Response to Agency Preliminary Comments on Labadie Energy Center §316(a) Draft Demonstration Study Report

MDNR/MDC Comments

Figure 1. Seasonal fraction of the fish community comprised of heat intolerant species as numbers (left) and biomass (right) in the vicinity of the LEC in 2017-2018.

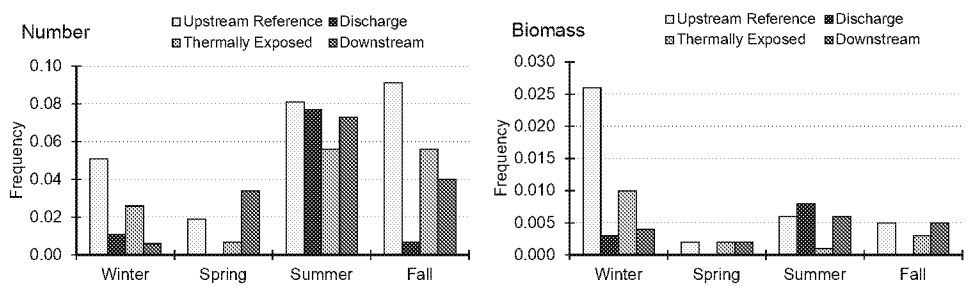
b. According to the text, there were no heat intolerant species counted in the discharge and thermally exposed areas, but Figure 5-19 appears to show the opposite.

c. In addition to this, please graph these by season as Section 6.3.3 indicates certain intolerant species will be completely absent if the river exceeds certain temperatures. Seasonal density graphs were completed for the macroinvertebrate community in Figure 5-24.

c. Graphs in Section 5 were selected to illustrate patterns in the data, without overwhelming the reader with more graphics than can be assimilated. The seasonal aspect of the prevalence of heat tolerant and intolerant species was incorporated into the analysis. The data for tolerant and intolerant species, segregated by gear and season, are provided in Appendix B Tables B-14 through B-17. The standardized differences between Upstream and either Thermally Exposed or Downstream zones, based on each of these combinations for fraction intolerant species are provided in Appendix B Tables B-18 through B-21. All of the standardized differences for each combination of gear x season, for both numerical abundance and biomass (without preference) were included in the overall weight of evidence, along with differences based on other metrics, in Figure 5-22.

To satisfy the request, figures similar to Figure 1 are provided in the Supplement (Section 3) to demonstrate the seasonal component of heat-intolerant species as it relates to numerical abundance and biomass.

Figure 2. Maximum temperature at the edge of the 25% Mixing Zone vs. TDP

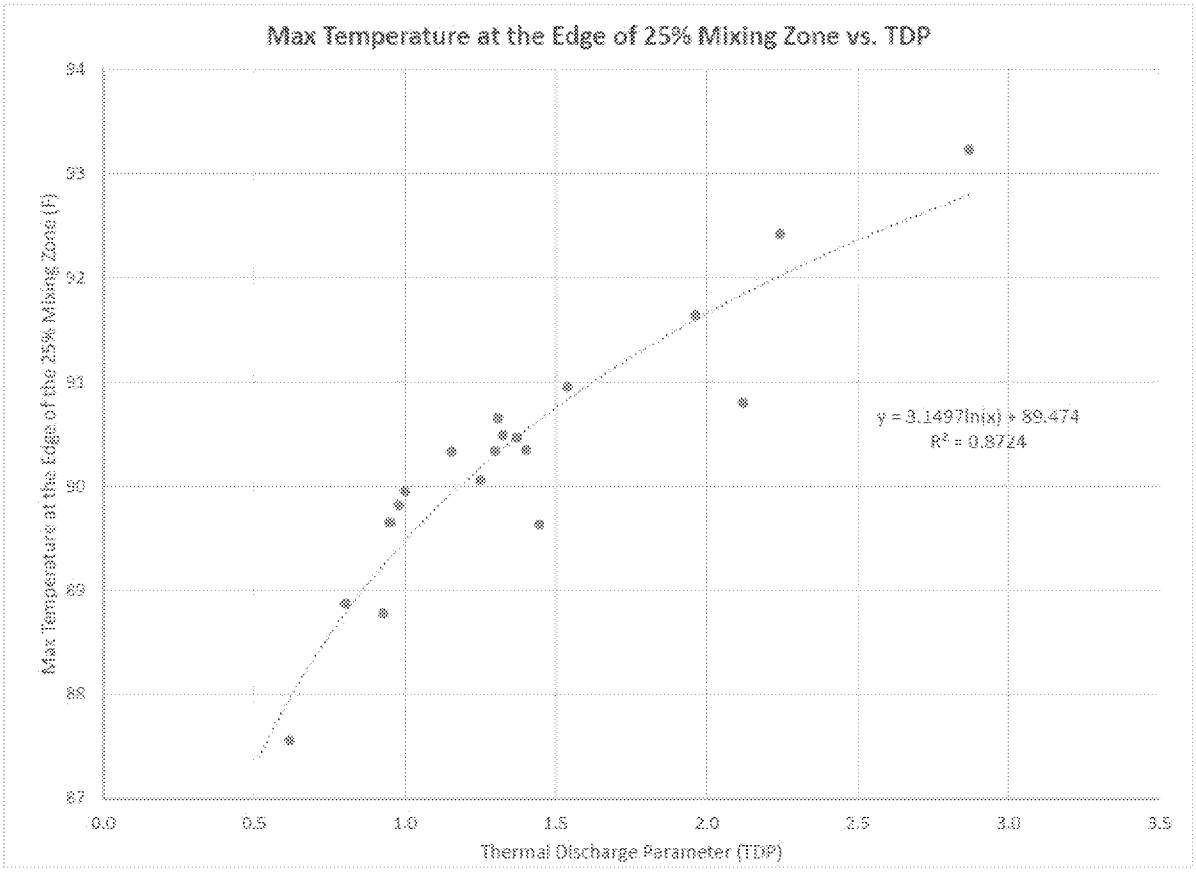
7. The Ameren variance request appears to be based on the logic of the Mississippi River criteria and this seems appropriate. The questions/comments below are based on that approach. While variable with river temperature, what is the more elevated temperature (>5°F) at the edge of the 25% mixing zone when the RMZ is expanded to 40% of the river? Does this equate to an additional 3°F increase above 90°F? Is the 40% value based on a calculated zone of passage or a maximum temperature at the higher RMZ? Ameren's variance request should define the increase in temperature above 90°F when the larger RMZ is allowed.

In response to this comment, we analyzed the model output from a subset of the previously conducted simulations that were run to develop the effluent limitation equations in Tables A-1 and A-2 of the NPDES permit. For each simulation, we determined the location along the river where the maximum temperature occurs after mixing with only 25% of the river flow. At all other locations, the temperature would of course be less than the maximum. The simulations analyzed represent a range of river and discharge temperatures and flows.

The results for the maximum temperature at the edge of the 25% mixing zone for each simulation are provided in the attached Figure. As expected, the Figure demonstrates that the maximum temperature is a function of the TDP. (Recall that the TDP is a composite measure of the combined effect of river and discharge flows and temperatures.) As can be seen, the maximum temperature at the edge of the 25% mixing zone will exceed 90°F at TDP values above 1, again as expected and as we have previously demonstrated. Nonetheless, the Figure further demonstrates that maximum temperature at the edge of the 25% mixing zone will always be below 94°F even for a simulation with TDP as high as 2.87. Analysis of the historical database (January 2002 – December 2018) indicates that TDP never would have exceeded 2.65. So, even when the variance may be invoked allowing temperature in the river to exceed 90°F in up to 40% of the river, the temperature will still be below 94°F in 75% of the river (i.e., be above 94°F in only 25% or less of the river), and will be below 90°F in 60% of the river (i.e., above 90°F in only 40% or less of the river). Furthermore, these maximum percentages will occur for only a small segment of the river and will be less at all other locations in the river.

For most instances during which the variance may be invoked the maximum temperature at the edge of the 25% mixing zone will only be one or two degrees above 90°F. For example, as shown in Figure 2, for a TDP value of 2.3, the maximum temperature at the edge of the 25% mixing zone will still only be about 92°F. And, TDP values at or above 2.3 would be extremely rare. The historical record shows that such has occurred on only 4 days out of 6018 days (less than 0.1% of the time). So, on days when the variance will be invoked, the maximum river temperature at the edge of the 25% mixing zone will typically be around one and almost always less than two degrees above 90°F, but never above 94°F.
